ADDENDUM NO. 2

DPW Project #2023256

April 30, 2024

**DPW/UI – Ag Science Building HVAC Phase Two
University of Idaho
Moscow, Idaho**

Design West Architects P.A. logo and contact information. Project title: UNIVERSITY OF IDAHO AG SCIENCE BUILDING HVAC UPGRADES, PHASE 2. DPW PROJECT #23256. 606 SOUTH RAYBURN STREET, MOSCOW, IDAHO 83844. Date: 02/05/2024. Sheet Name: COVER SHEET. Sheet Number: G1.00.

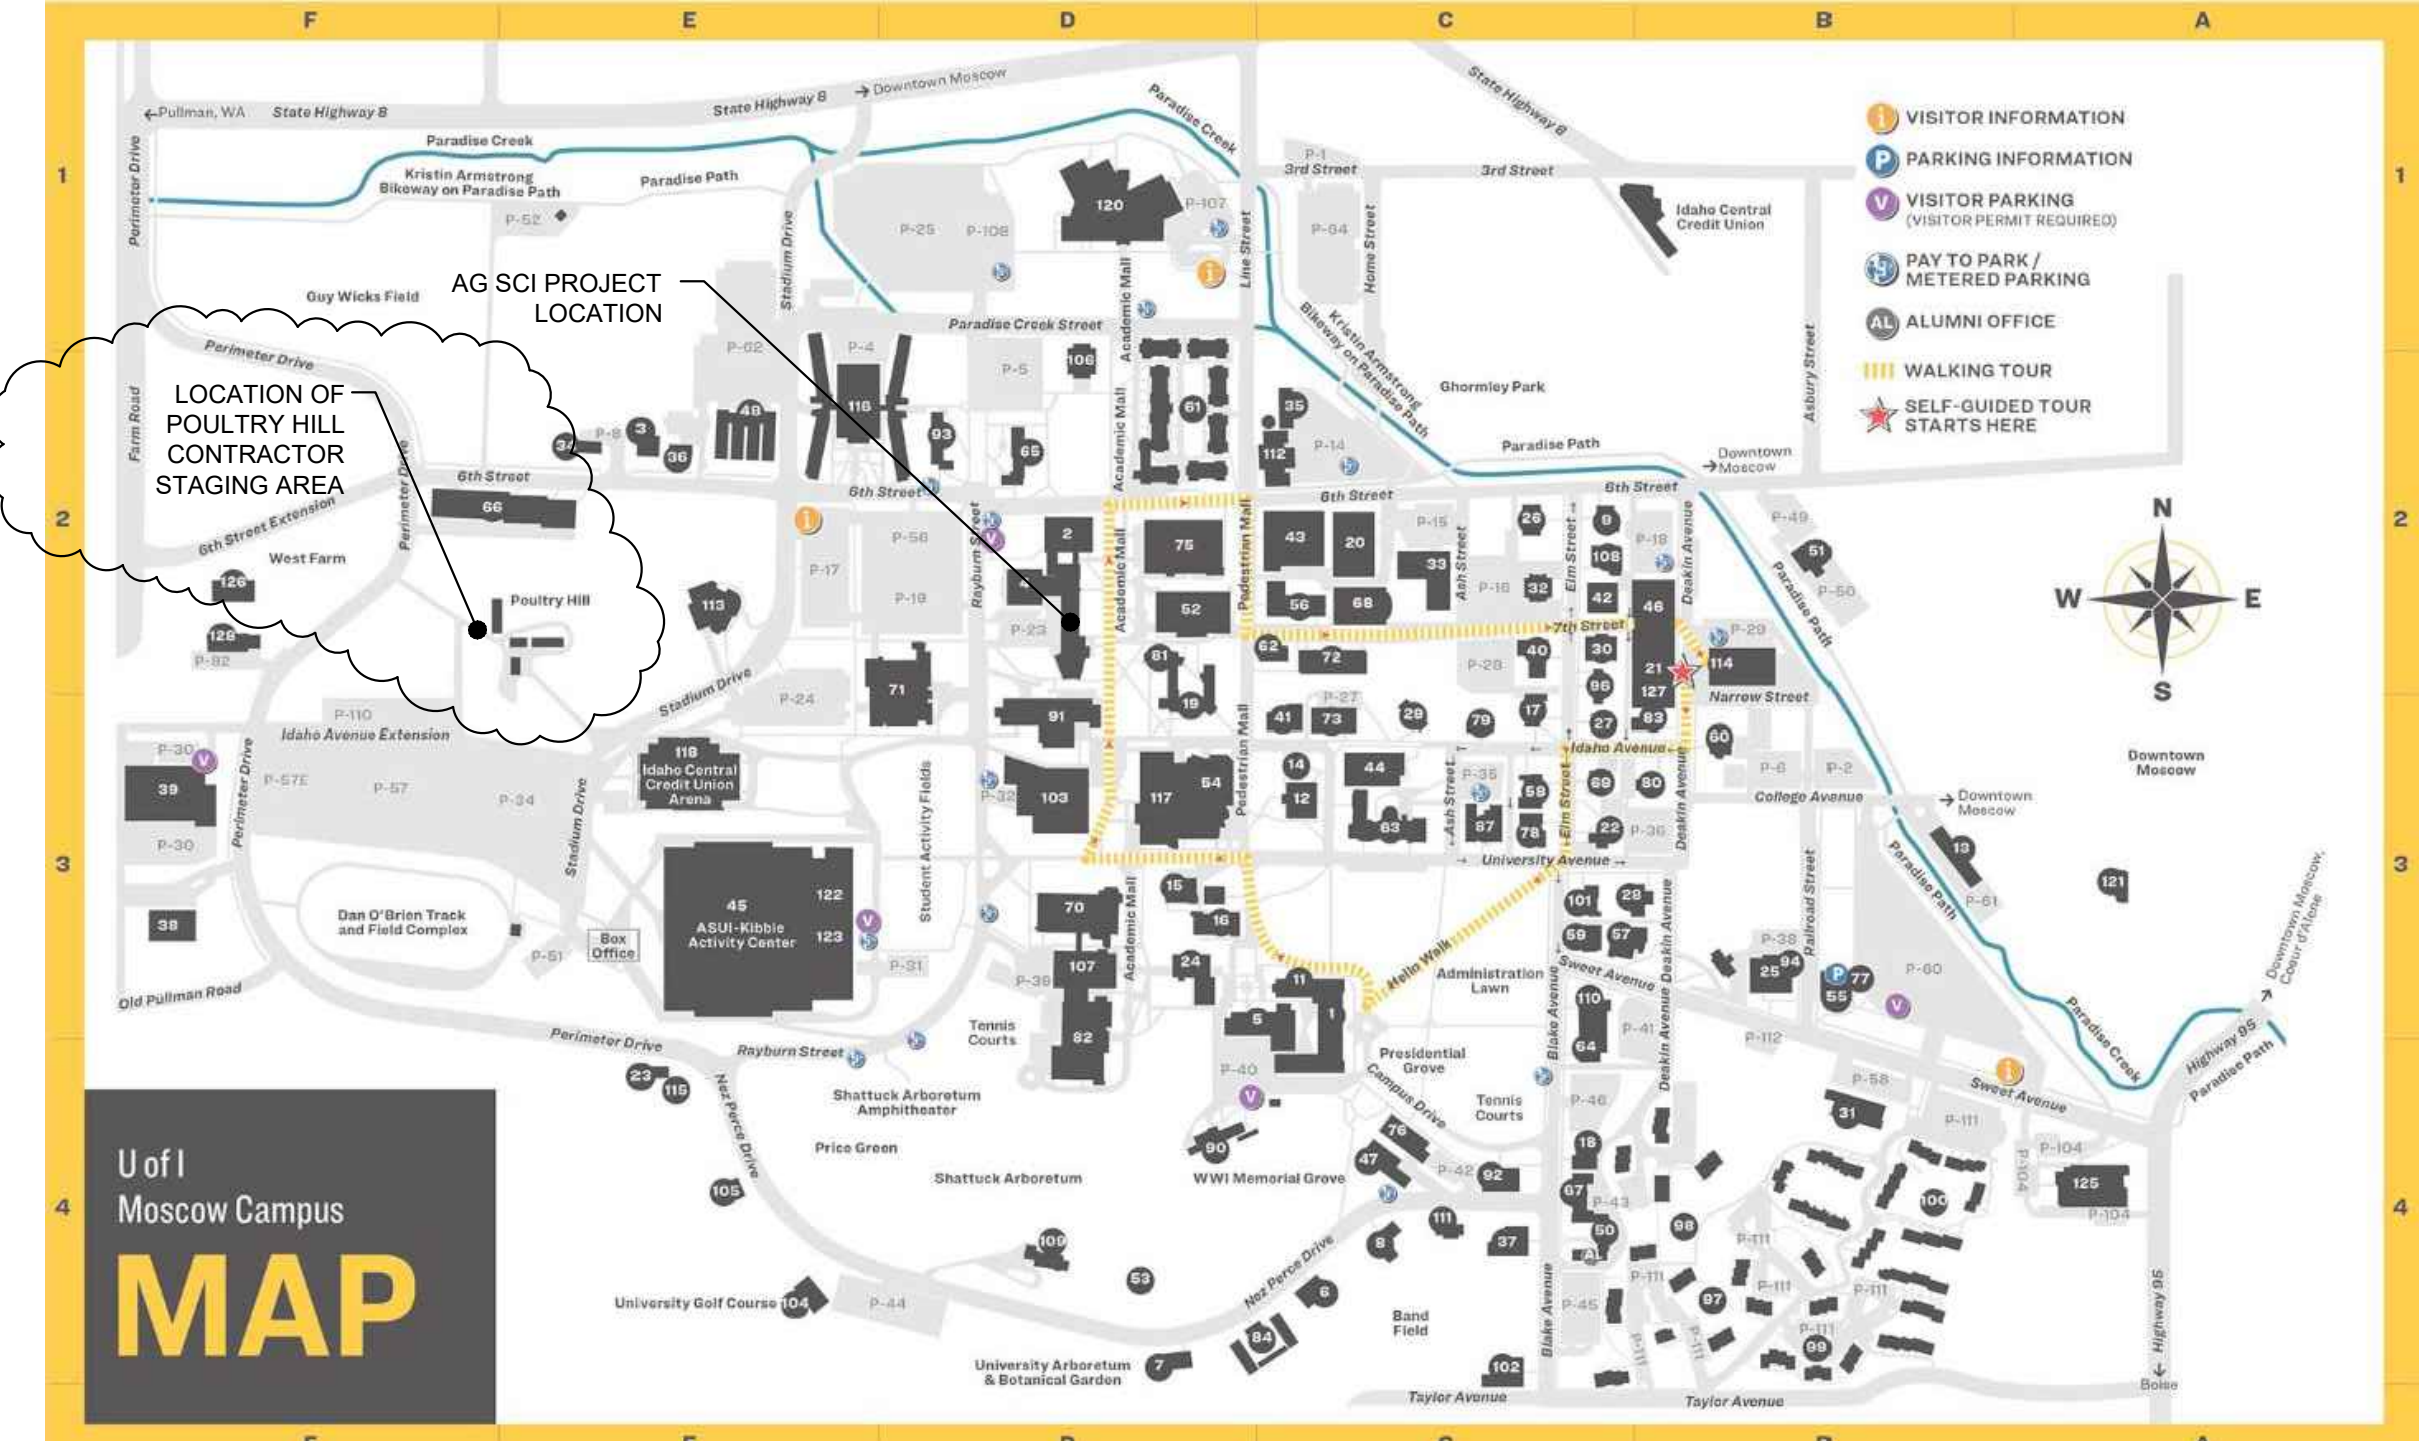
CLARIFICATION: See added note on the attached Sheet G1.00 to indicate the location of Poultry Hill on the Campus Map.

REVISION: See revised Drawing Index for Electrical and Telecom sheets on the attached Sheet G1.00.

GROUND FLOOR PLAN AREA C

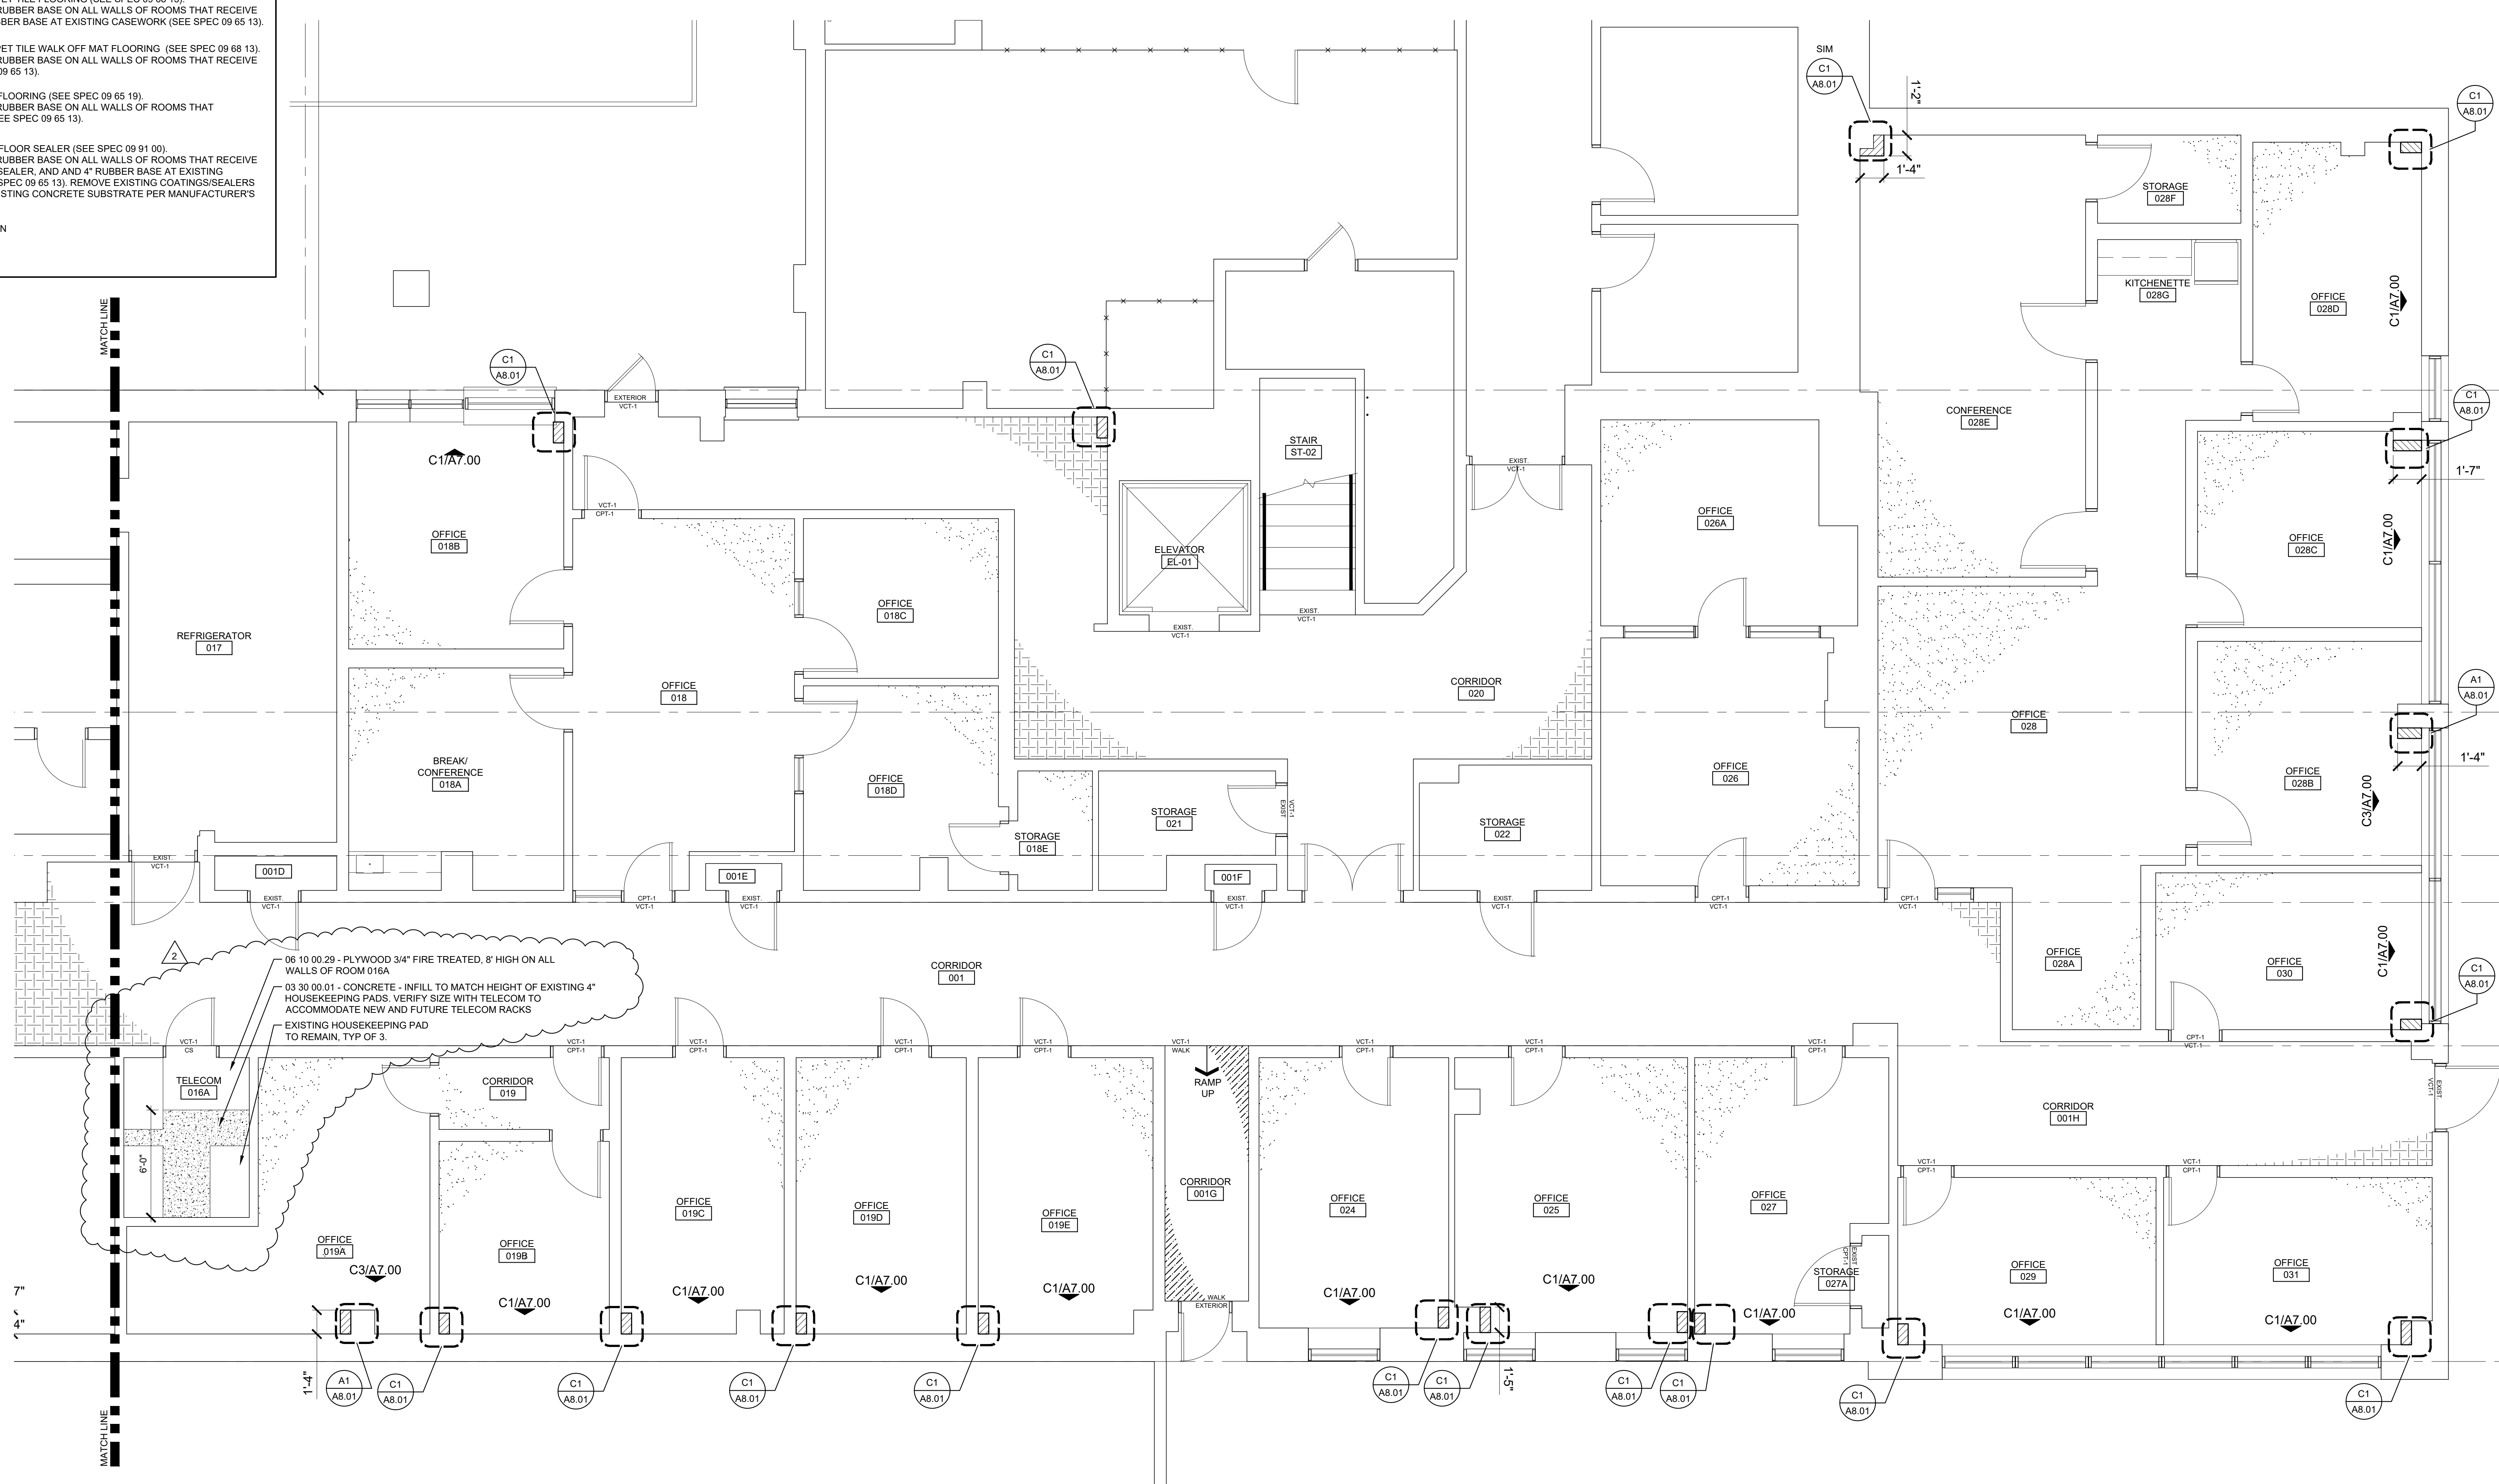
REVISION: Revise room 016A as shown on the attached Sheet A3.30C.

A1 REFLECTED CEILING PLAN - SECOND FLOOR - AREA A

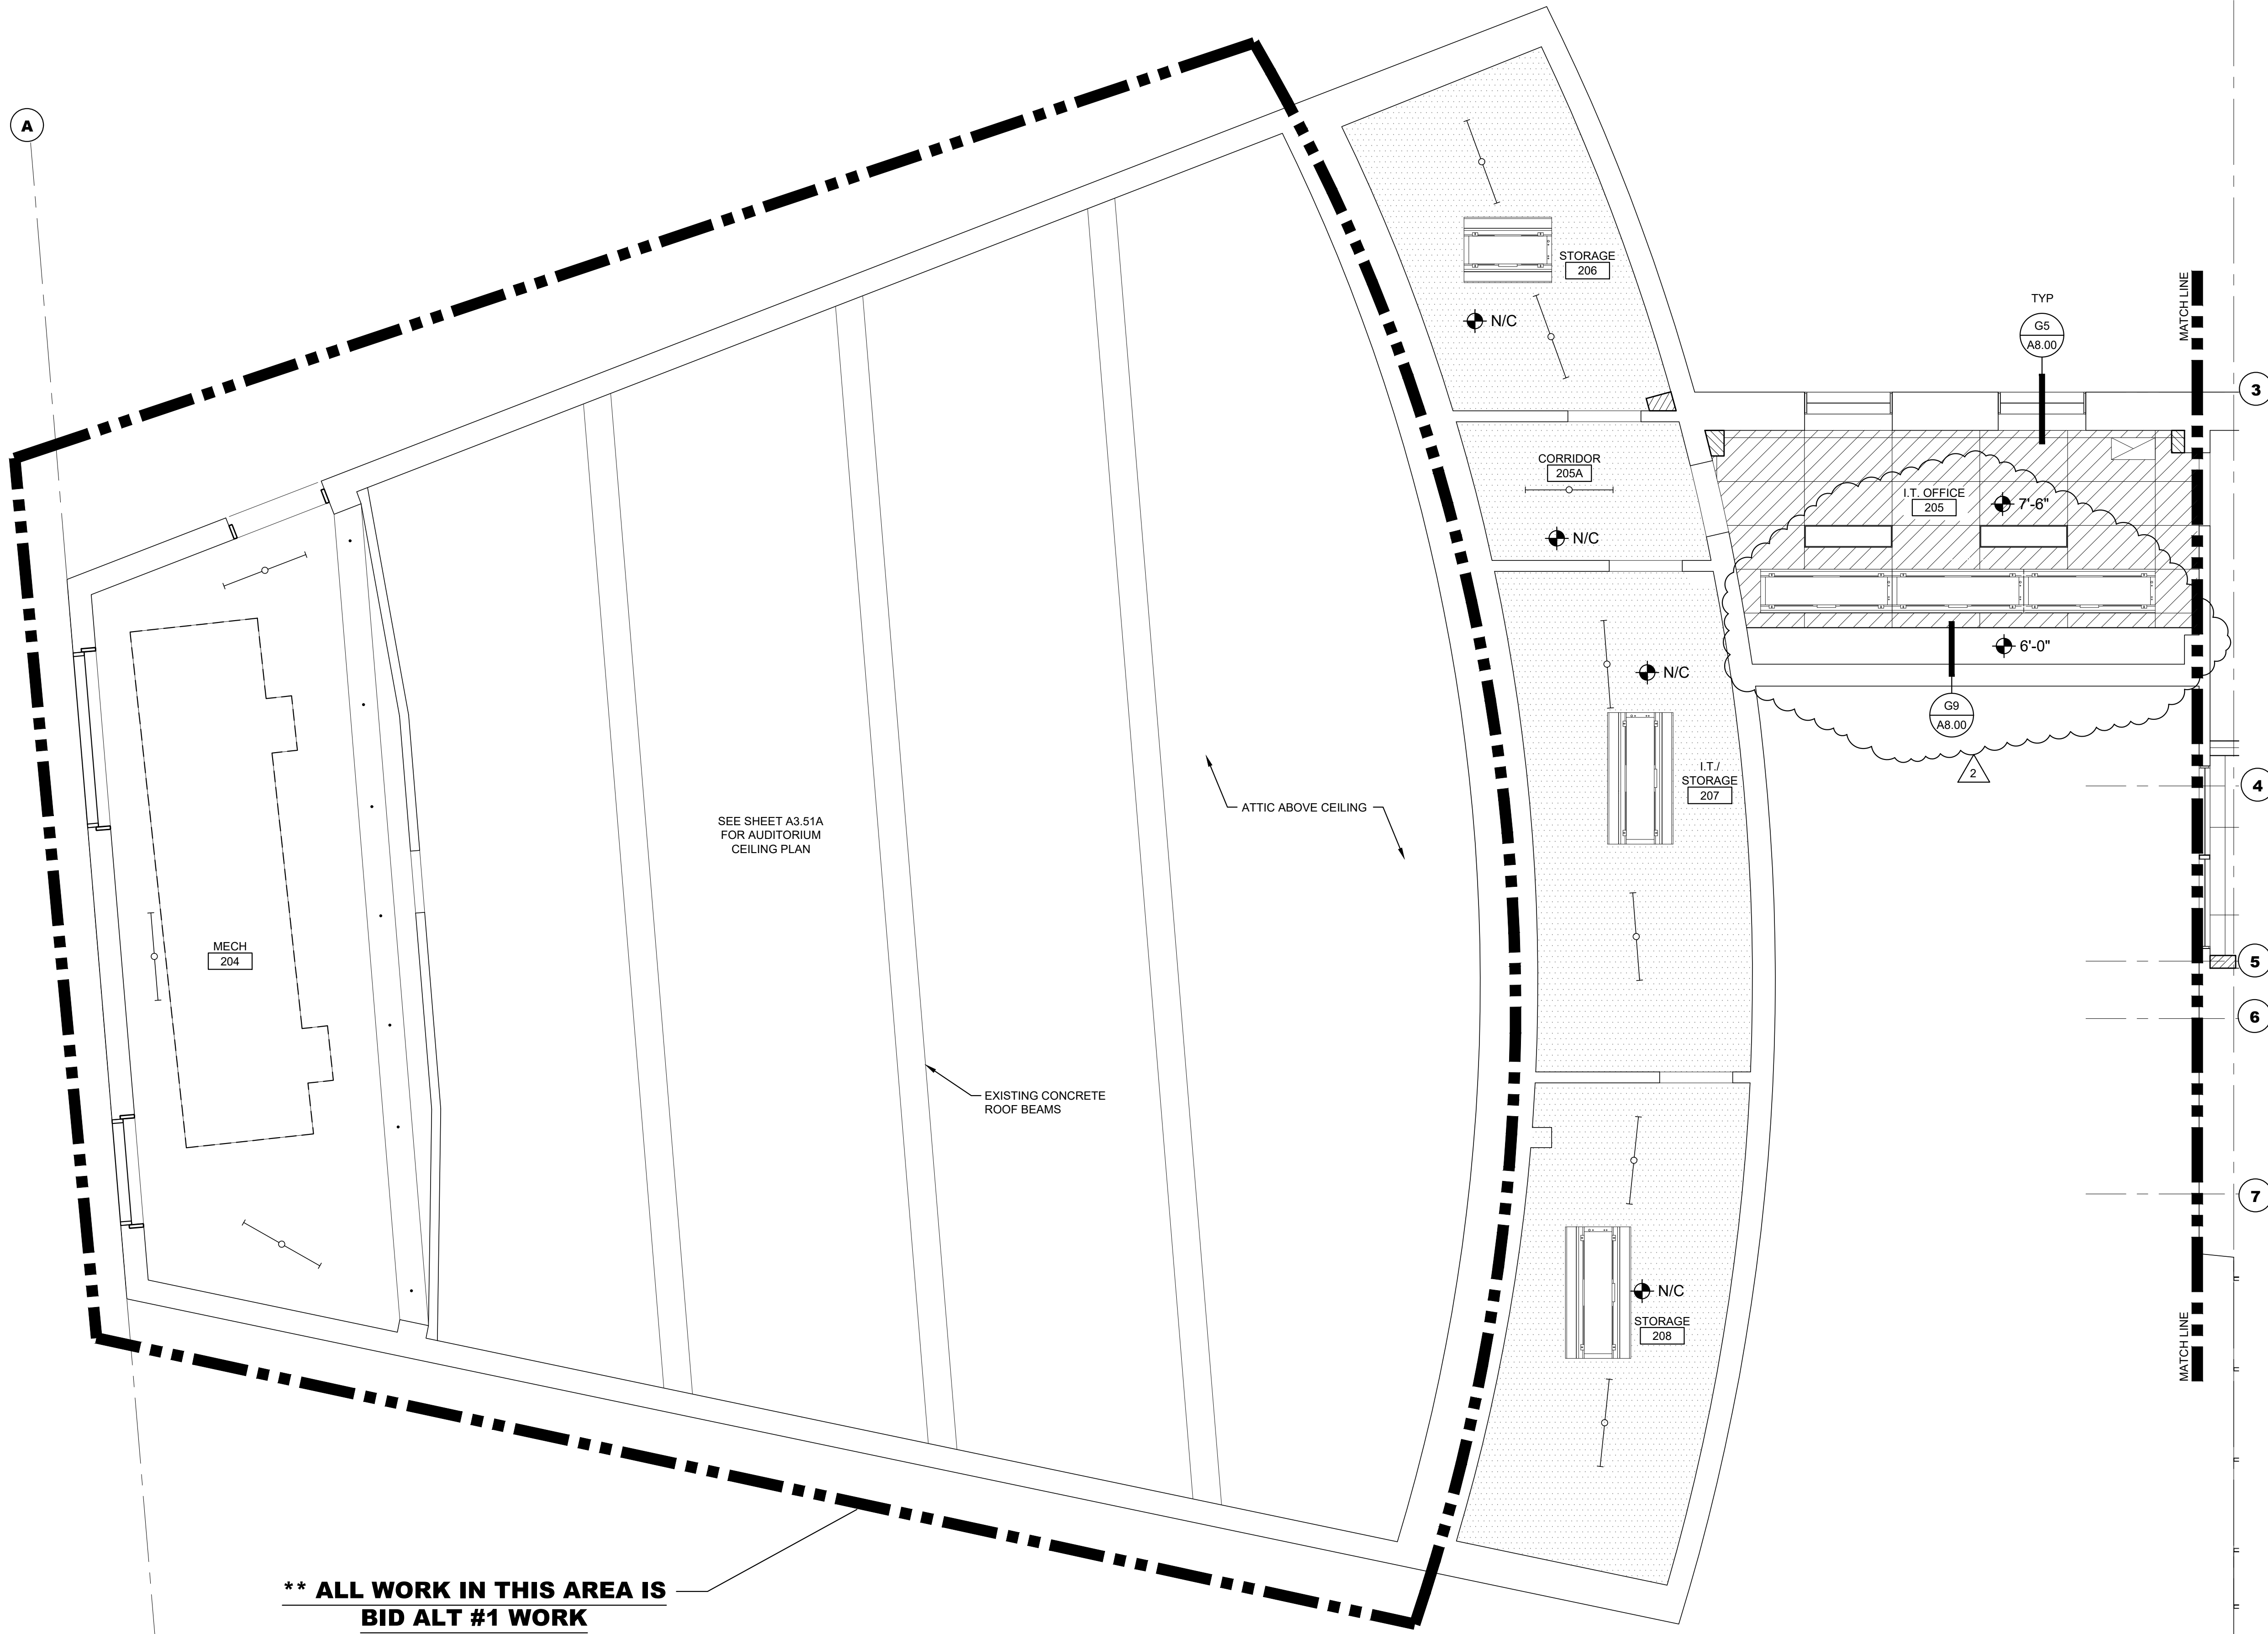
REVISION: Revise Room 205 ceiling as shown on the attached Sheet A3.52A.
